RE: **Lot 21 Block 1 Volcano Cliffs Unit 22 SAD 228  
8012 Agua Fria Ct. NW  
Grading and Drainage Plan  
Engineers Stamp Date 10/21/2020 (D10D003N21)  
Pad Certification Dated: 5/10/2021**

**Re: Pulte at Volcano Cliffs Unit 18  
Erosion and Sediment Control Plan  
Engineer's Stamp Date 6/17/2021 (D10E003\_P)**

PROJECT NAME:  
PETROGLYPH ESTATES  
8012 AGUA FRIA CT  
PULTE ID 21

SHEET TITLE:  
GRADING AND  
DRAINAGE PLAN

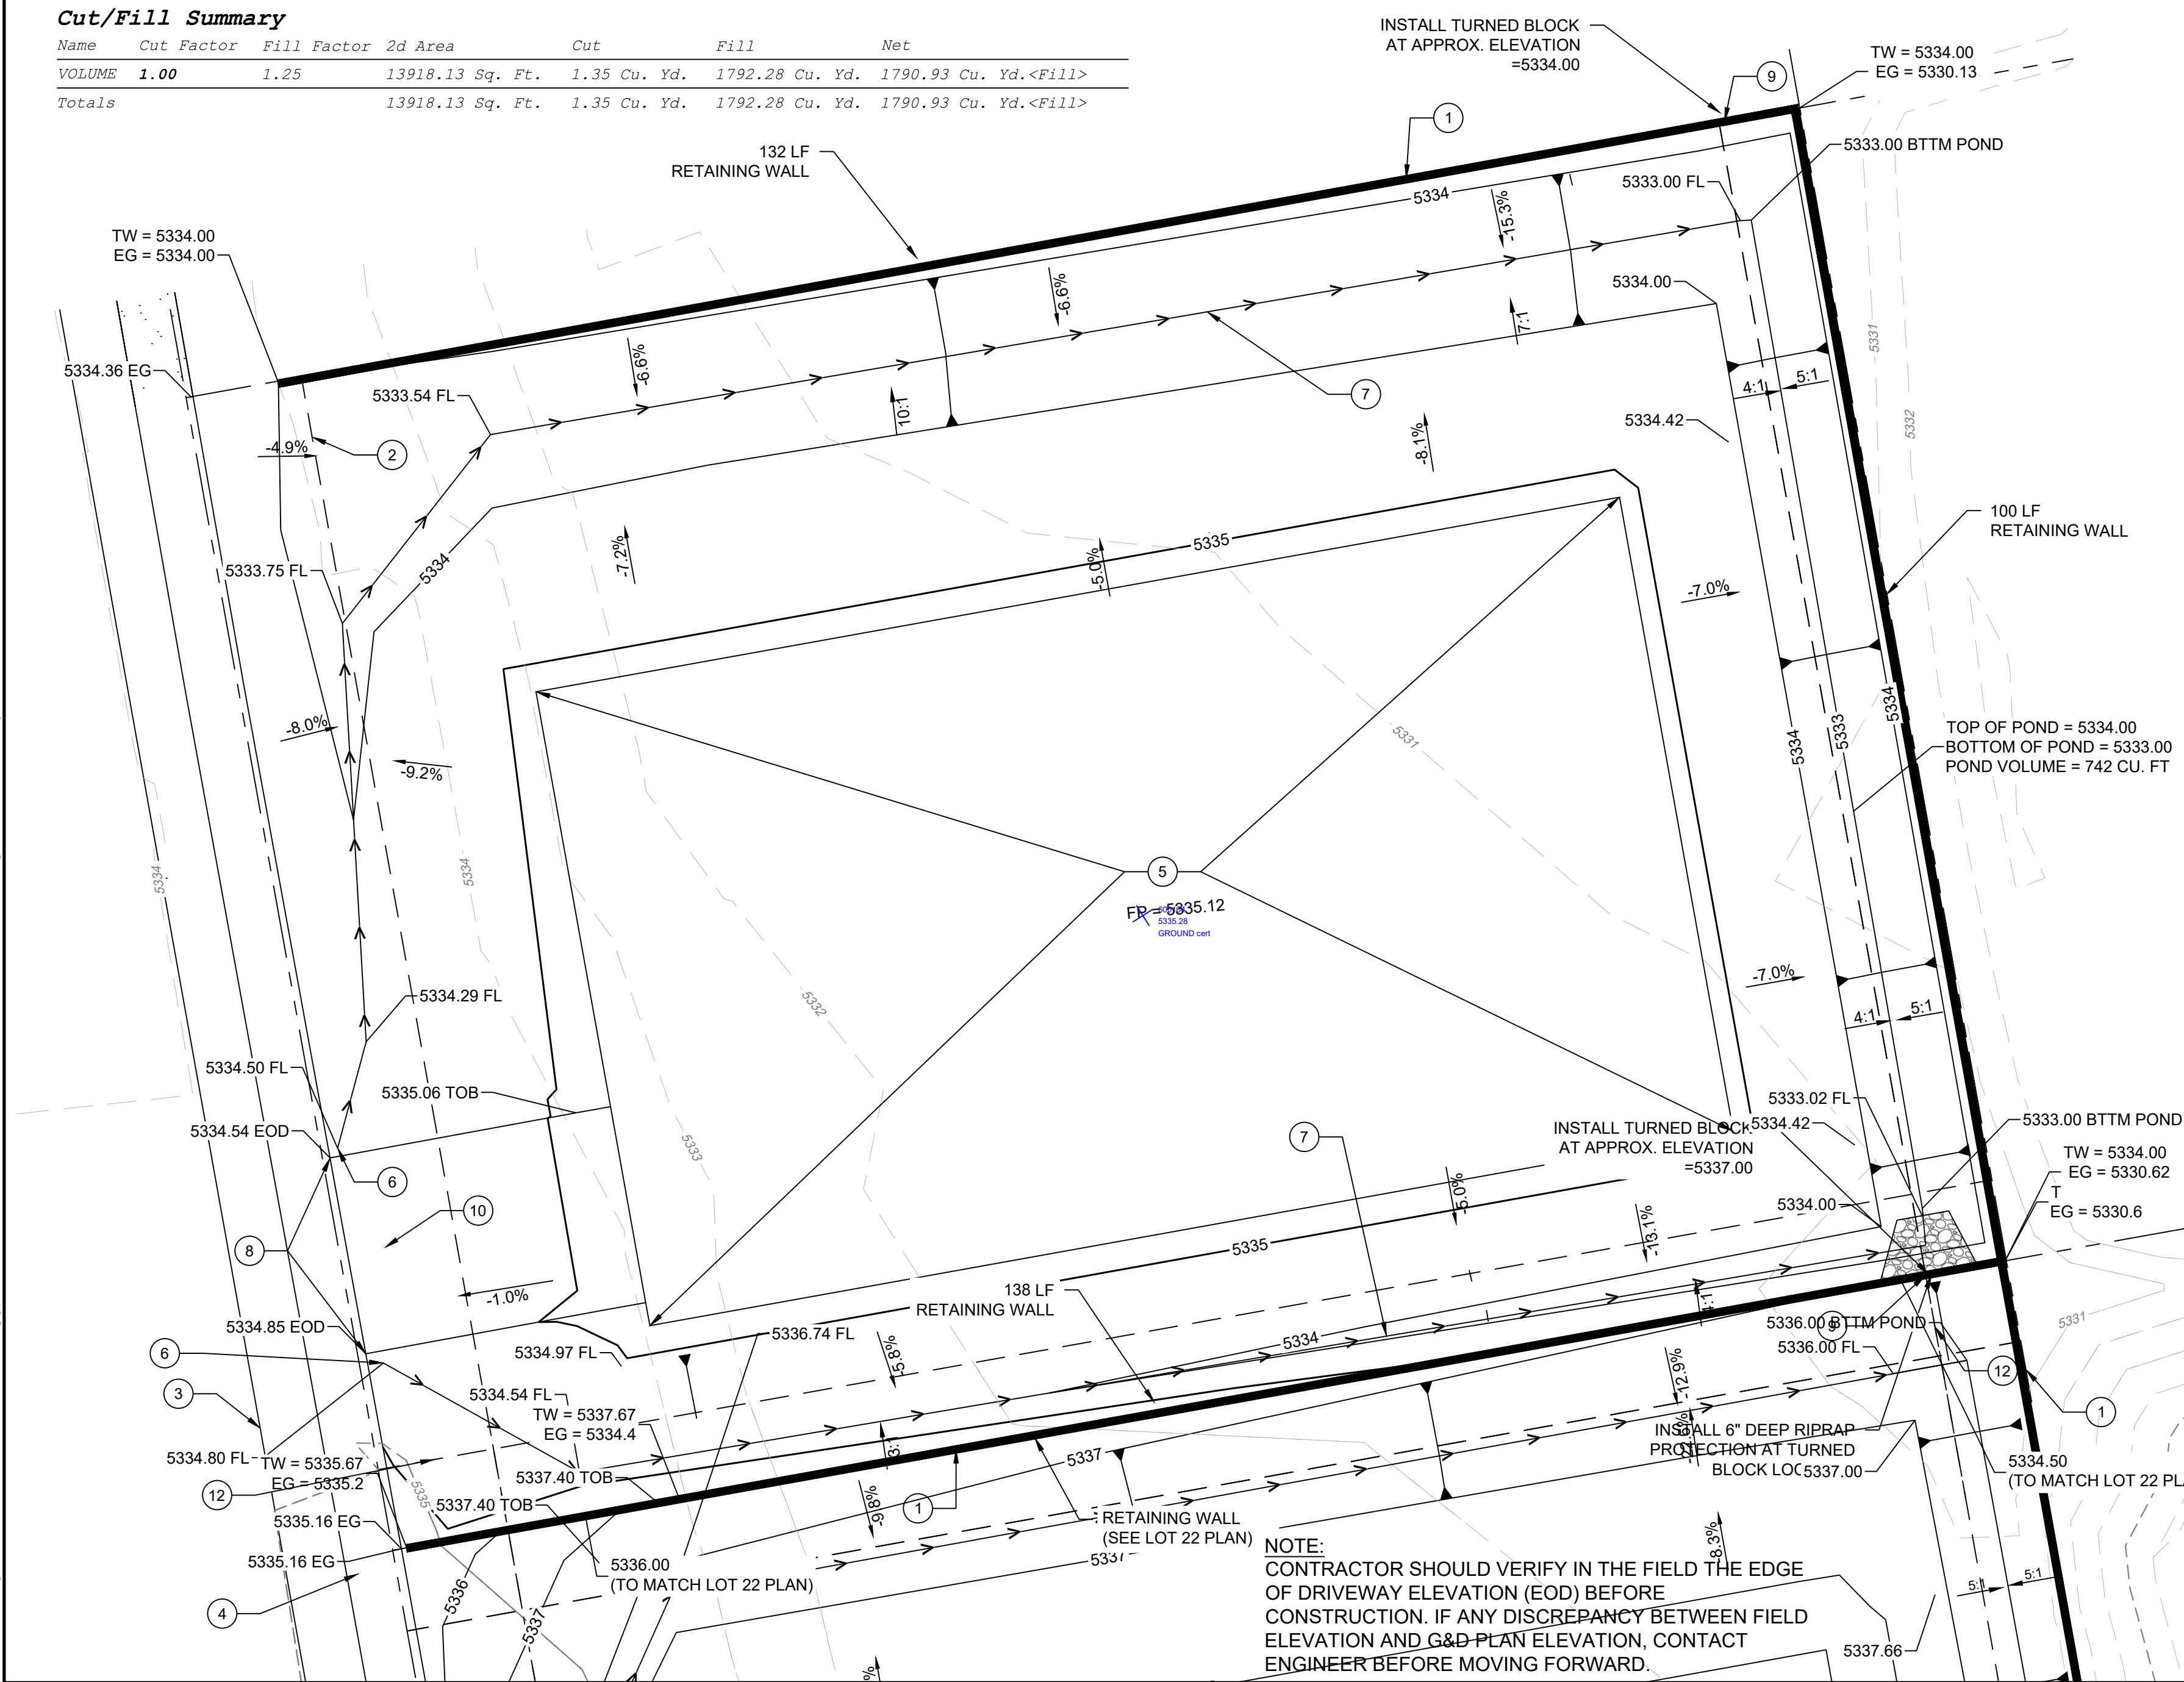
Based upon the information provided in your submittal received 6/25/2021, this plan is approved for Building Permit.

Reiterate to the Owner/Contractor that a separate permit for a garden/retaining wall must be obtained with the approved G&D plan and Pad Certification. **Also, if a swimming pool is to be placed the grading and drainage plan will change and will need to be resubmitted showing location of pool and land treatment changes.**

**Prior to Certificate of Occupancy release, Engineer Certification per the DPM checklist will be required.**
